## BGA TECHNICAL COMMITTEE

### TECHNICAL NEWSHEET 7/8/97

PIRAT S.Z.D. 30  
WORKS NO B 534  
BCA NO 1819.  
BUILT 13<sup>th</sup> FEBRUARY 1972

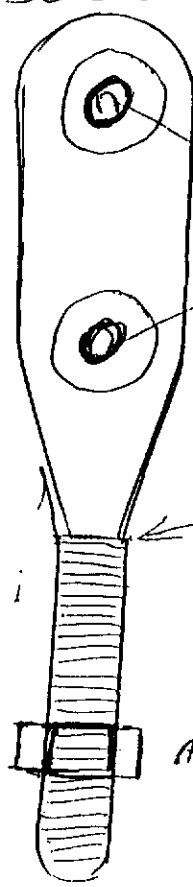
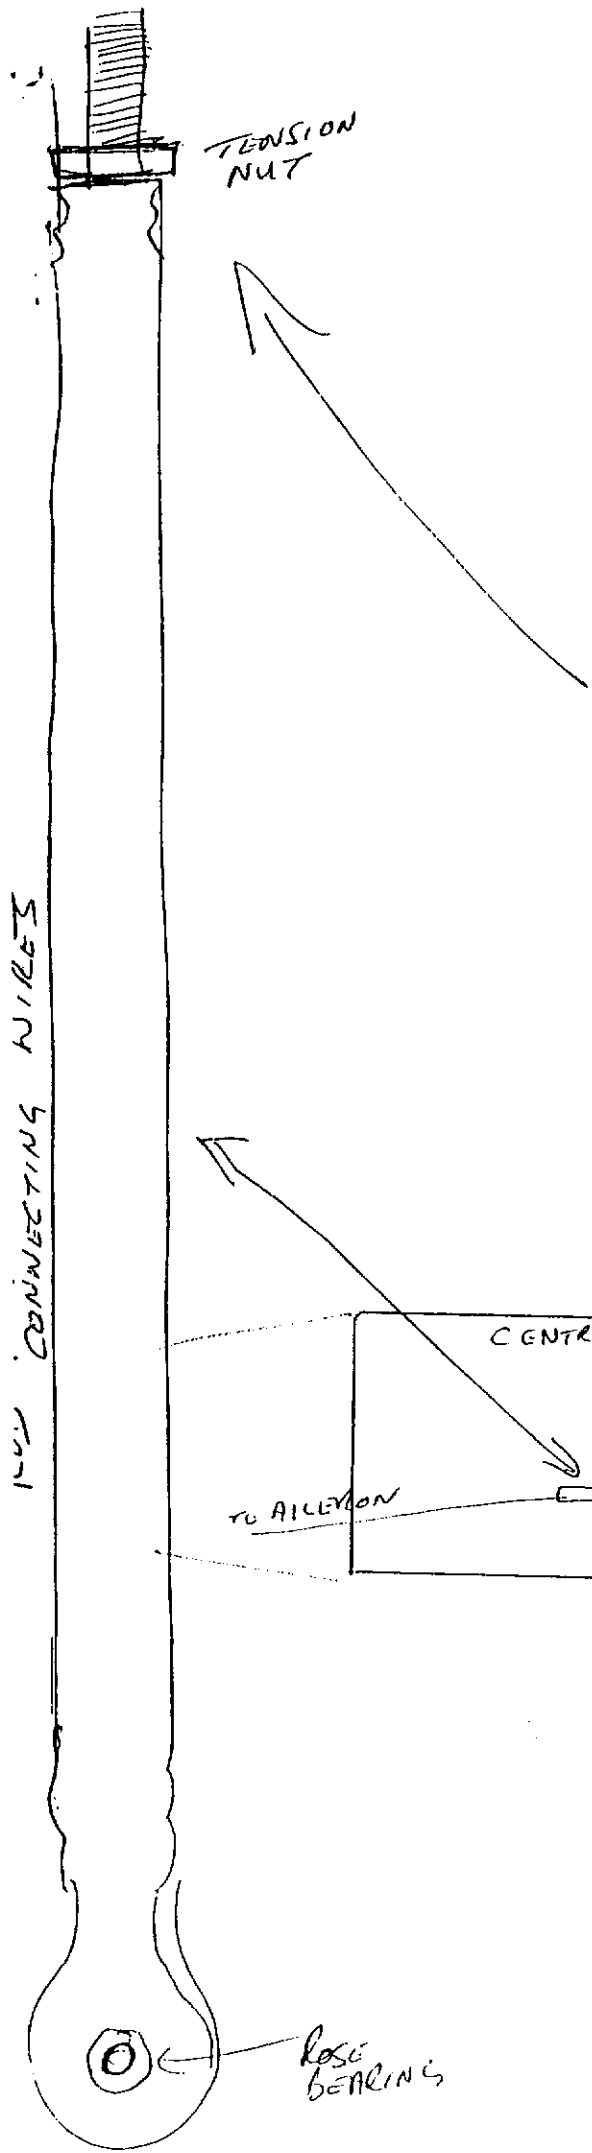
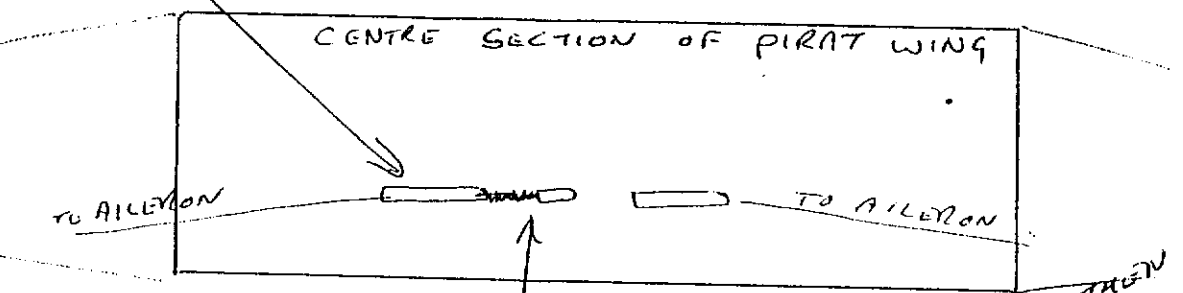
- 1.7.     PIRAT Aileron Connecting Rod damaged during rigging / de-rigging. (Sketch herewith).
  - 1.8.     LS4/LS4A Increase in Service Life to 12000 Hrs. Subject to multi-stage inspection at 3000 hrs. Tech Bulletin 4027 a enclosed.

STRESS FRACTURE  
(COMPLETE BREAK)  
CAUSED BY TURN BUCKLE  
BEING PUT UNDER STRESS  
WHEN LIFTING WING SECTION  
IT OFTEN GOT STUCK UNDER  
CONTROL ROD.

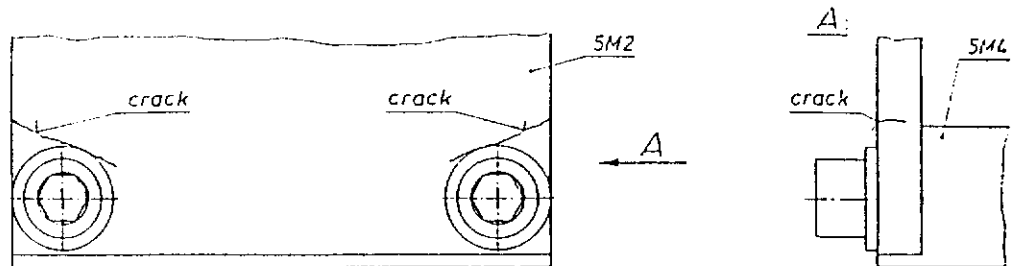
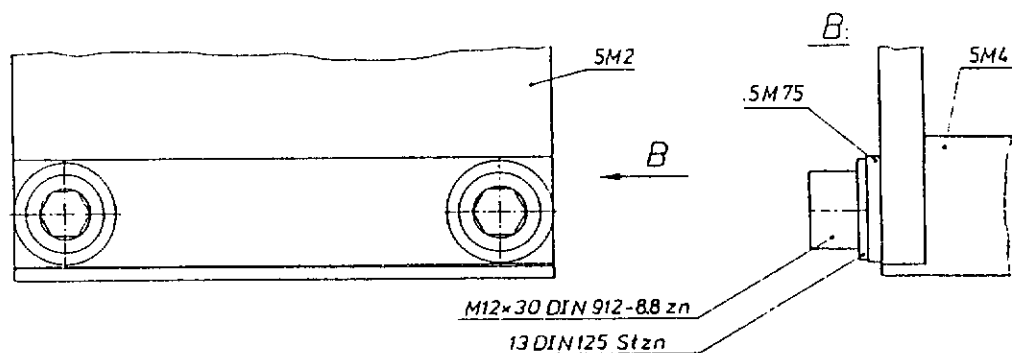
- Reason:**
1. On an inspection cracks were found in the propeller mounting plate 5M2 (s. maintenance manual diagram 11) near to the bolts connecting the plate to attachment 5M4. Prior to the next flight the propeller mounting plate must be inspected for cracks in the affected area. This item is also added to the 25 hour inspection of the powerplant. In addition an aluminium plate 5M75 must be inserted between propeller mounting plate and washers to avoid undesirable stressing of the propeller mounting plate.

- Instructions:**
1. The critical areas (at the lower end) of the propeller mounting plate must be inspected for cracks. To accomplish this first remove the bolts at the front face of the propeller mounting plate including washers, then clean the plate with a cloth. Now have a close look at the surrounding of the fixing bolts and the edges (s. sketch) using a magnifying glass (magnification min. 5x). Due to remains of lubricant soaked into the cracks they are easy to detect.

Because cracks might also start from impressions of the washers check this area very carefully. If cracks are detected or only suspected the propeller mounting plate must be replaced by a new part SM2.

Moreover an aluminium plate SM75 must be inserted between propeller mounting plate and washers for better stress distribution. Use longer bolts M12x30 DIN912-8.8zn instead of existing bolts to fix the propeller mounting plate.
